Addendum #02

Delaware Army National Guard

Bid Pack A – NDI Room Upgrades

Bid Pack B – Paint Room Upgrades

SKM-001.1

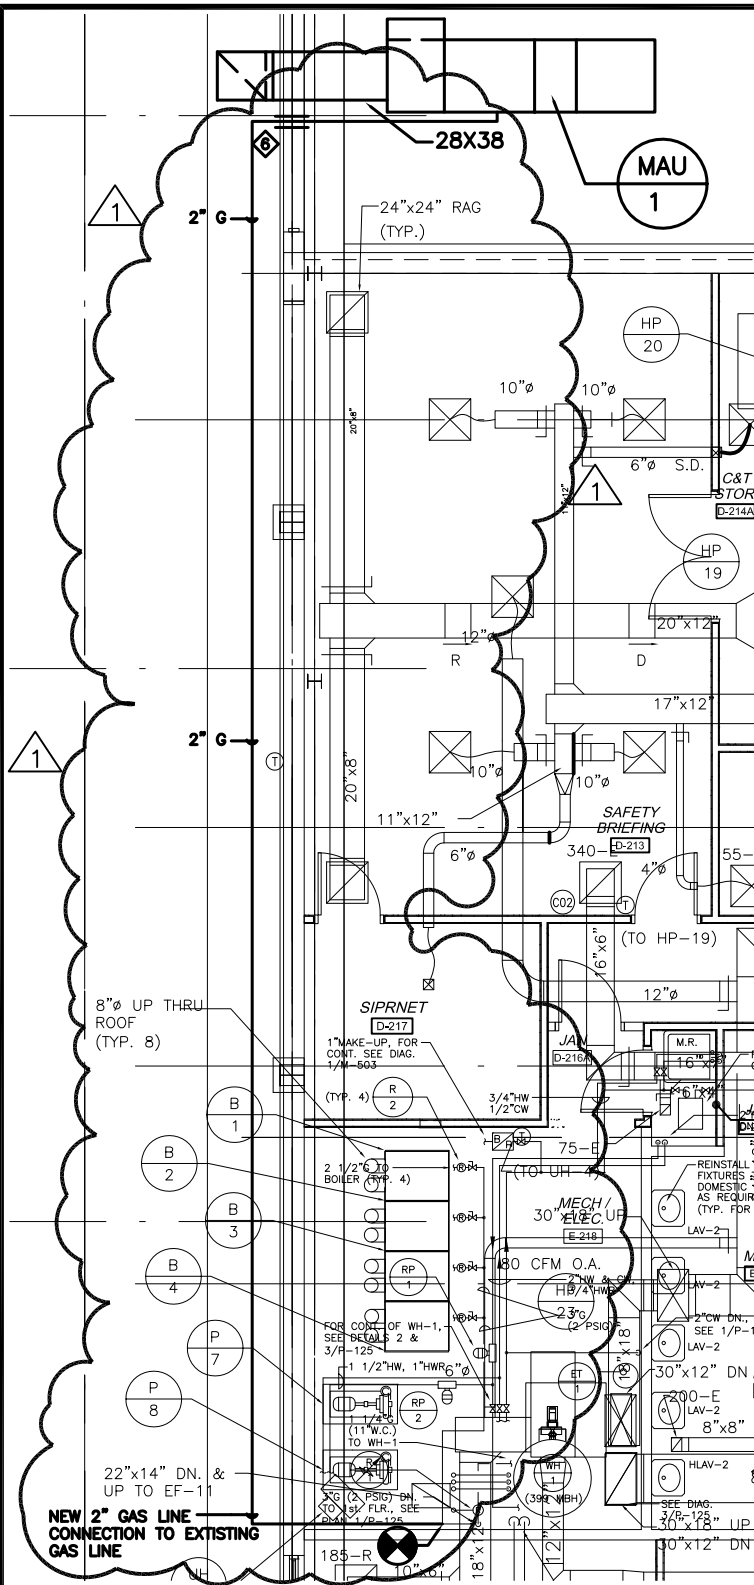
- A. **ADD** Sketch SKM-402.1 Bid Pack B indicating exhaust fan stack detail.

D. Is the new axial exhaust fan for the booth to be mounted inside of building or up on the roof?

E. How high above lower roof can we terminate the stack from the spray booth? I have figured 6'.

Response: On the roof as indicated on Drawing M-402. Refer to Sketch SKM-001.1 Bid Pack B for clarification.

Response: There is an operable window in Classroom D-124 within 10 feet. The Exhaust Fan is located 6 feet from the window and the code requires it to be 10 feet from operable openings. The location of the fan is not flexible. As a result the top of the discharge needs to be at 8 feet. Refer to Sketch SKM-001.1 Bid Pack B for clarification.

SKM-402.1

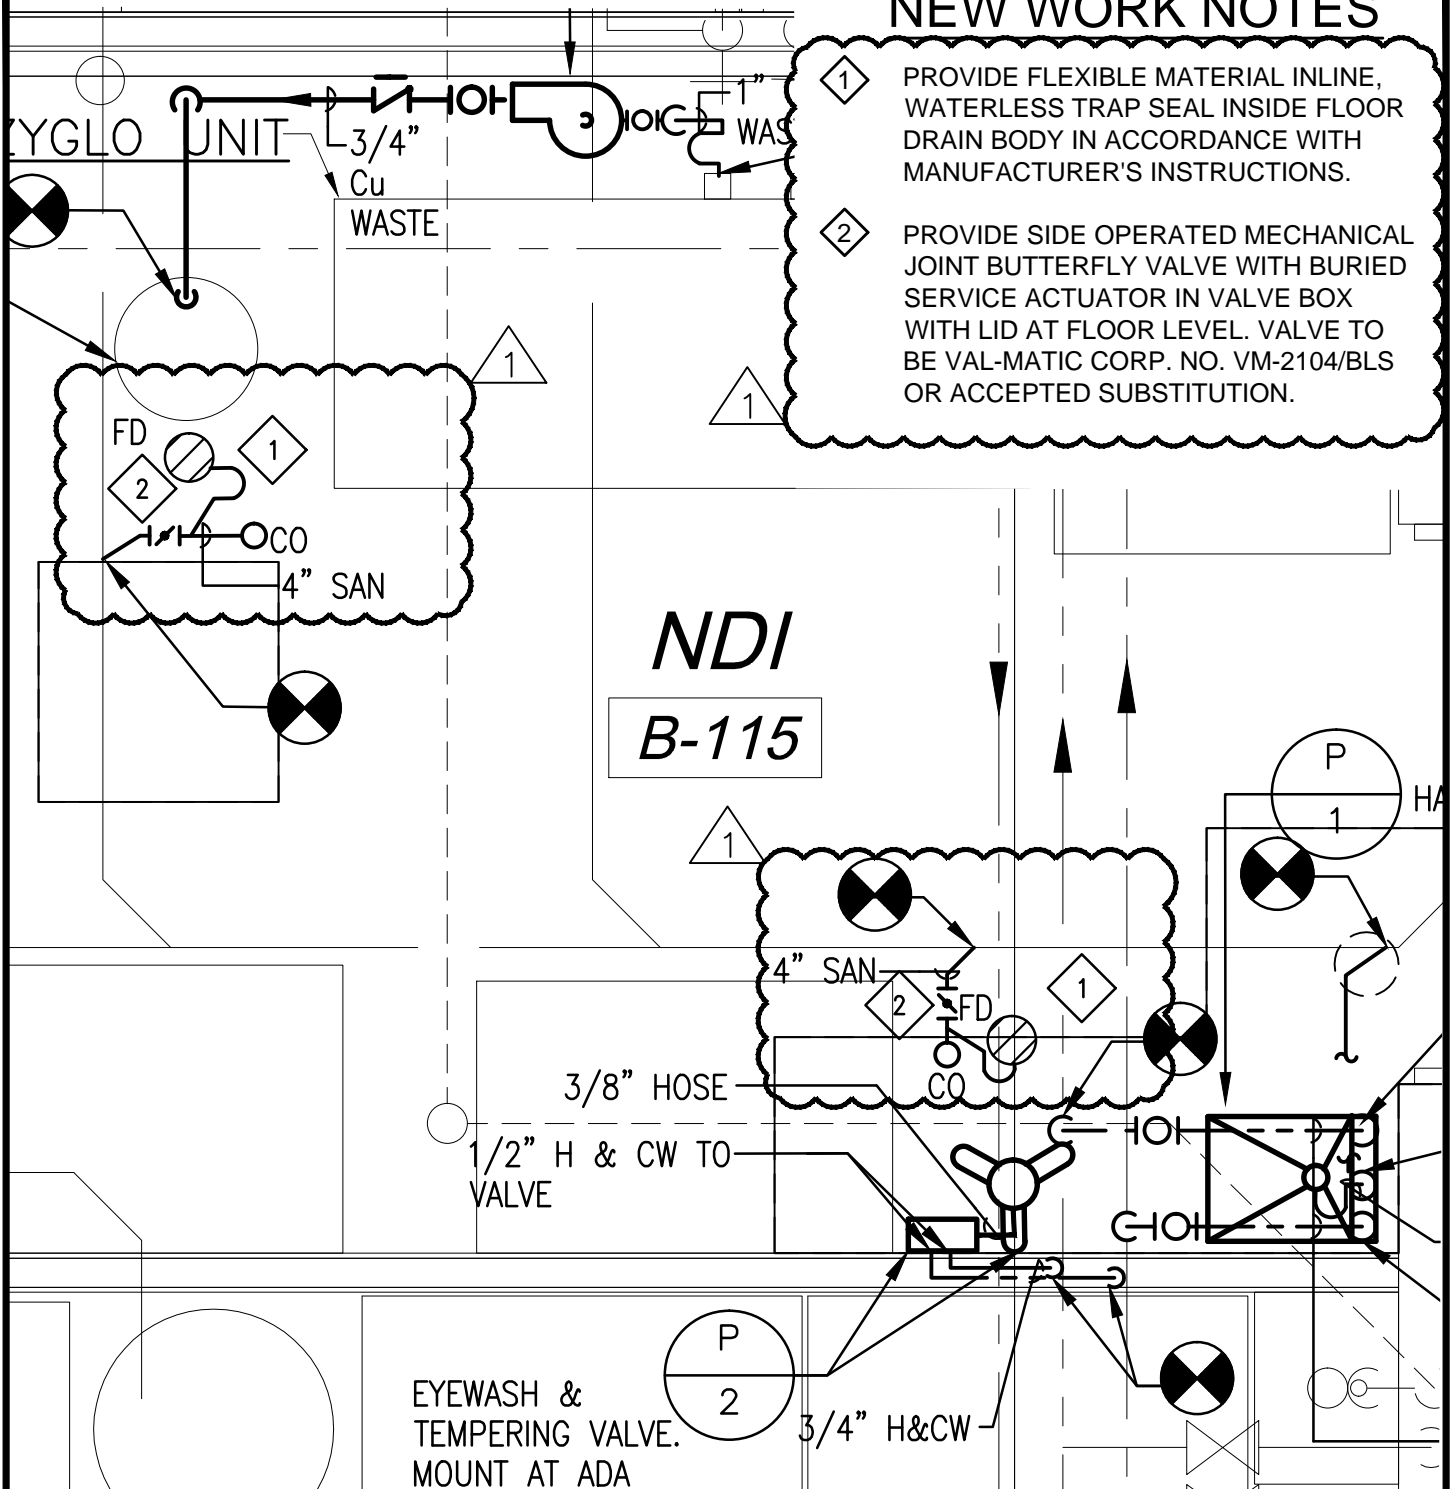
- A. **ADD** Sketch SKM-001.1 Bid Pack B indicating the required gas piping.

- B. Where is the gas connection for the new MUA unit on the roof? There are no gas lines shown anywhere.

Response: The gas line has been added under this Addendum. Refer to Sketch SKM 402.1 Bid Pack B.
